ASSESSMENT REPORT

18 Honeysuckle Drive, Newcastle SSD 6580 MOD 1

4. PROPOSED MODIFICATION

Figure 2: Circled in red, proposed internal changes (left) and approved changes (right)

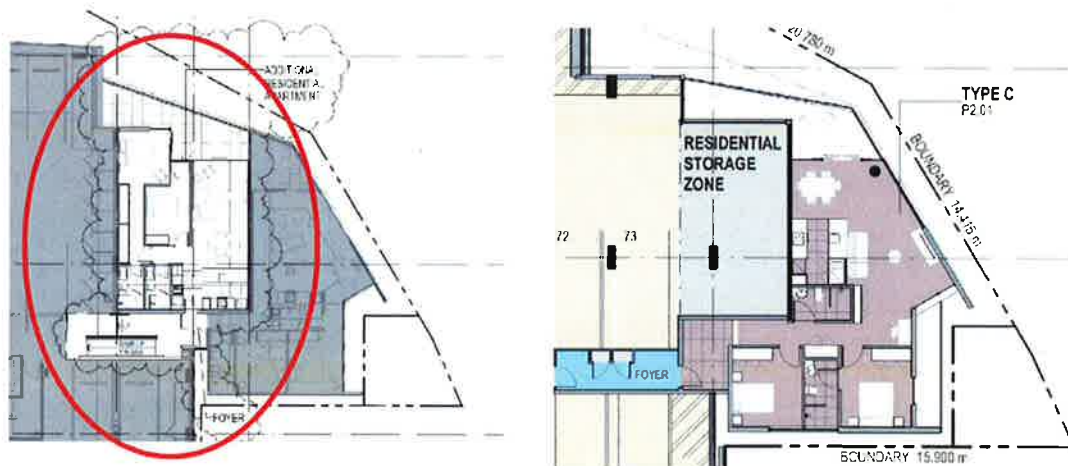
On 4 January 2016 the Proponent lodged an application (SSD 6580 MOD 1) seeking to amend approved plans to include an additional two bedroom unit, accessible from the carpark on level two, and to make some minor changes to the carpark layout.

The modification is requested on the basis that the inclusion of an additional apartment on parking level two will provide better integration with the façade and improved surveillance of the street frontage along Honeysuckle Drive.

Issue	Consideration	Recommendation
<i>Built Form and Urban Design</i>	<ul style="list-style-type: none">• The proposal seeks approval to include an additional apartment within level 2 of the approved building. The proposed changes are predominantly internal and would not materially change the approved built form or the appearance of the building from the public domain.• The only perceptible external change to the building would be a small change to the balcony and balustrade alignment as shown in Figure 2 and Figure 3. This is considered to be a minor change which would improve the appearance of this part of the building.• The Department is therefore satisfied that the integrity of the overall building design will be retained.	No additional conditions or amendments necessary.
<i>Floor Space Ratio</i>	<ul style="list-style-type: none">• The additional apartment would increase the Gross Floor Area (GFA) of the development by 77sqm. This would increase the Floor Space Ratio (FSR) from 3:1 to 3:02:1.• Council raised concerns that the proposed development had not addressed clause 4.6(3) of the Newcastle Local Environmental Plan (LEP), 2012, relating to exceptions to development standards.• However, the Department has confirmed that the FSR applicable to	No additional conditions or amendments necessary.

Figure 4: Newcastle LEP Floor Space Ratio Map

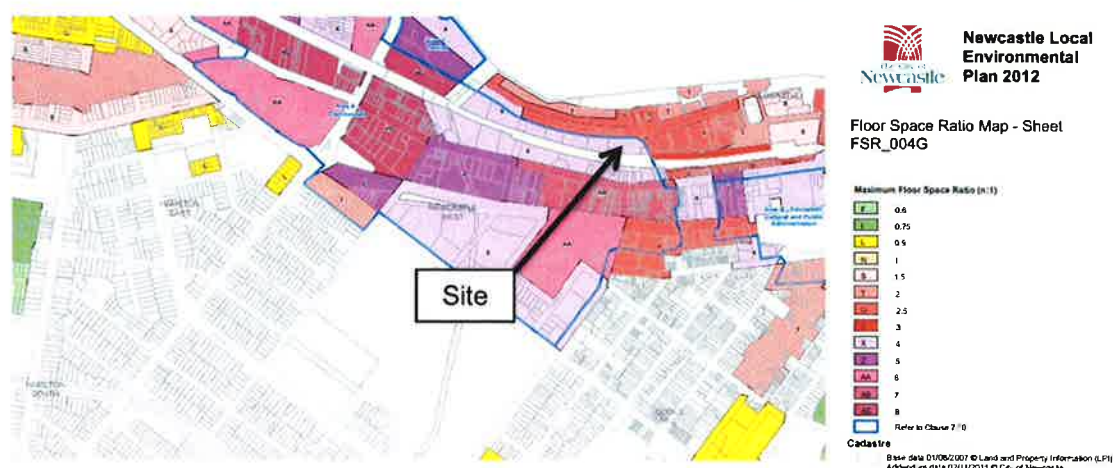
Newcastle City Council did not object to the proposal, but asked that the applicant address clause 4.6(3) of the Newcastle Local Environment Plan, 2012, relating to Exceptions to Development Standards as the proposal exceeds the prescribed Floor Space Ratio (FSR) for the site. Council also requested the Proponent to demonstrate compliance with the relevant Australian standards for parking facilities in terms of aisle widths and parking space dimensions within the Level 2 car park. Council outlined that as the modification would increase the cost of the development, the Section 94A development contribution would also increase.

Issue	Consideration	Recommendation
	<p>the site is 4:1 (refer Figure 4).</p> <ul style="list-style-type: none"> Therefore the increase in FSR to 3:02:1 fully complies with the development standards of Newcastle LEP 2012. The Department is therefore satisfied the development does not contravene the prescribed FSR for the site and a written submission under Clause 4.6 is not required. 	
Residential Amenity	<ul style="list-style-type: none"> The proposal has been considered against the provisions of State Environmental Planning Policy No.65 – Design Quality of Residential Flat Development and the accompanying Apartment Design Guide (ADG). An assessment against the key design criteria of solar access, ventilation, unit size, ceiling height, storage facilities, and balcony size is set out in Appendix C. The assessment demonstrates that the new apartment would meet most of the design criteria in the ADG, with the exception of cross ventilation. While the apartment is not cross ventilated the Department is satisfied that the apartment would still receive good levels of amenity as it is orientated to the north which maximises solar access, water views and sea breezes at this location. The Department is therefore satisfied that the additional unit would have an acceptable level of residential amenity. 	No additional conditions or amendments necessary.

Figure 5: Proposed Relocation of Storage Cages

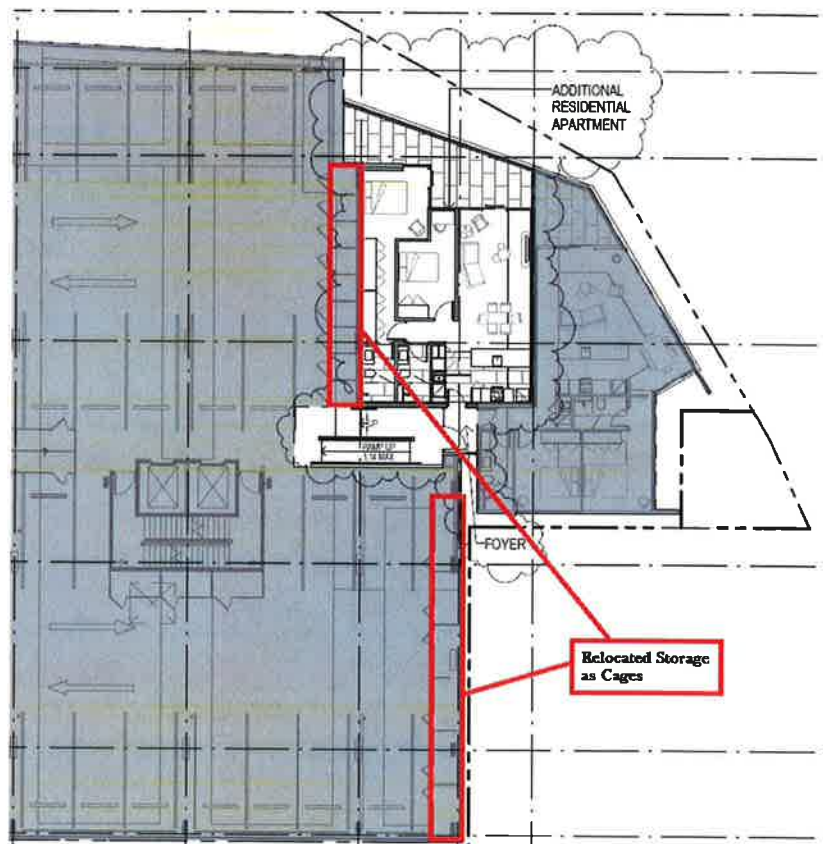
<i>Storage Facilities</i>	<ul style="list-style-type: none"> The proposal seeks approval to relocate storage cages, to accommodate the additional two bedroom apartment on Level 2. The relocated position of these storage cages is shown in Figure 5 and was clarified in email from DWP Suters architects dated 29/01/2016. The modification proposal increases storage cages by 1, from 71 to 72, in line with the increase in apartment numbers. The Department is satisfied that the proposal provides adequate storage facilities for all apartments. 	Yes
<i>Balconies</i>	<ul style="list-style-type: none"> The proposal results in a small reduction in the size of the balcony of the adjoining unit. Despite the reduction in size, the balconies of both units comply with the requirements of the ADG in that they have a depth of at least 2 metres, which is the minimum requirement for a 2 bedroom apartment. 	Yes
